PLANNING DIVISION STAFF REPORT

July 29, 2019

Project Address: 223 South Pinckney Street (District 4- Ald. Verveer)

Application Type: Demolition Permit, Planned Development Alteration, Conditional Use, and Certified Survey Map

**Above: West Wilson Street - Lower Levels of Hotel
Proposed May 7, 2019 Alteration**

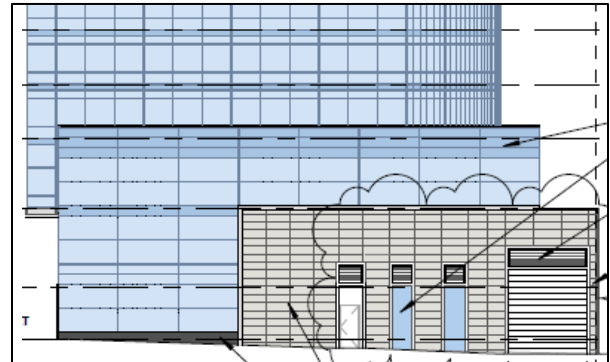
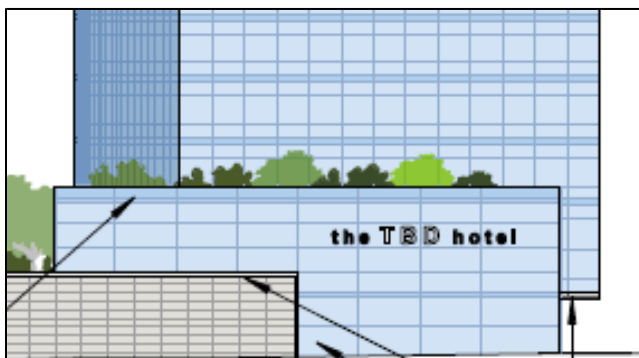
Corresponding façade changes are proposed to the East Wilson and Doty Street facades. Along Wilson Street, the previously approved underground parking entrance is now comprised of a door and spandrel-clad panels. Along Doty Street, additional windows and doors to an enclosed bike parking area are now proposed. No changes are proposed along South Pinckney Street.
